RE: Oconee Unit 1
Docket No. 50-269

JUSTIFICATION FOR FULL POWER OPERATION
IN AN UNRODDED MODE

PROPOSED TECHNICAL SPECIFICATION
CHANGES

FIGURE 2

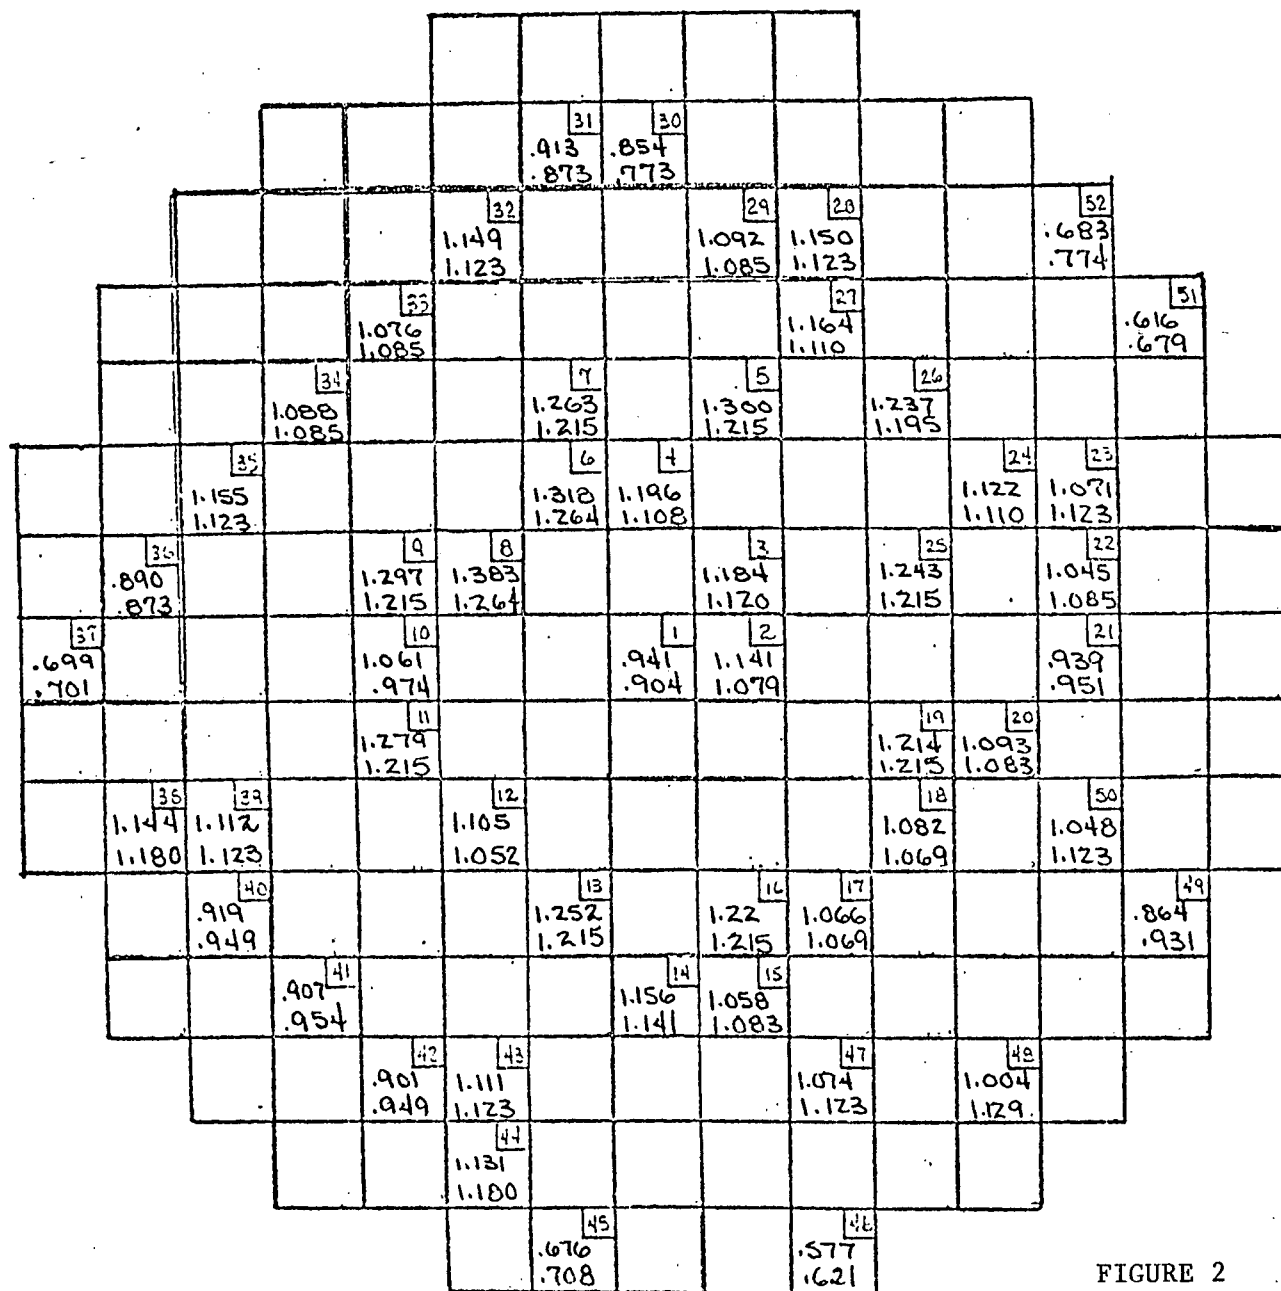
- a) this represents the relationship between peaking and tilt established by many full-core PDQ calculations with induced tilts, and
- b) the comparison of calculated and measured power distribution shown in Figures 1 and 2 at 40 and 75% of full power show that a factor of 1.09, in conjunction with the standard total and radial nuclear uncertainty factors would be conservative.

Figure 3.5.2-1A1

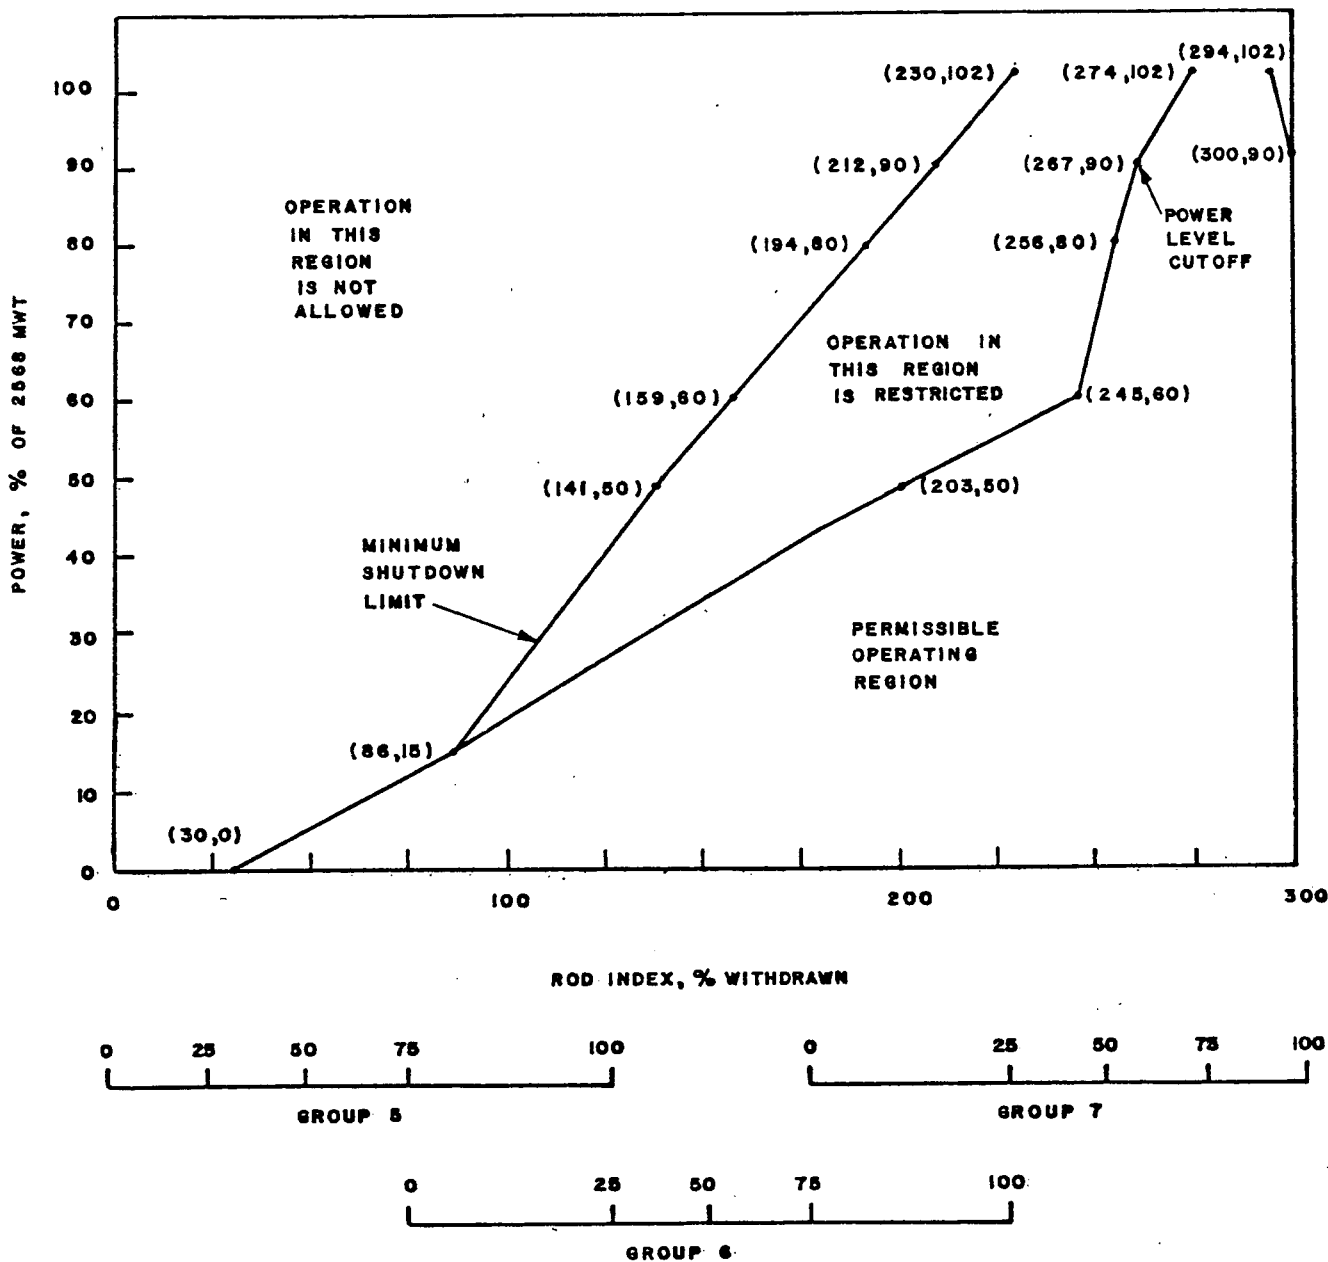
Table 1 provides a comparison of the total peaks calculated during each time step of the fuel cycle through 100 EFPD. Operation in the unrodded mode was found to provide reduced total peaks during the fuel cycle at all times after the 4 EFPD time step compared to rodded operation. Since the base peaking is lower for the unrodded cores the perturbed peaking is also lower. This is especially true when bank 7 is confined to the range of 295% WD to 274% WD at full power, as restricted by the proposed Figure 3.5.2-1A1.

The shutdown rod insertion limits were determined using standard techniques based on symmetric conditions and adjusting these calculations to account for the tilt. The calculated stuck rod worths are increased over 50%. The measured values of banks, 5, 6 and 7 at HZP were also used to determine the shutdown margin rod insertion limits. As an added conservatism the BOC calculated total rod worth was used at 100 EFPD to determine the limits at this time. The result of this procedure is the conservative shutdown rod insertion limits shown in Figures 3.5.2-1A1 and 3.5.2-2A1.

- c. Position limits are specified for regulating and axial power shaping control rods. Except for physics tests or exercising control rods, the regulating control rod insertion/withdrawal limits are specified on figures 3.5.2-1A1,
(Unit 1); 3.5.2-1B1, 3.5.2-1B2 and 3.5.2-1B3 (Unit 2);

OCONEE 1 CYCLE 4 ROD POSITION
LIMITS FOR FOUR PUMP OPERATION
FROM 0 TO 100 (+10) EFPD
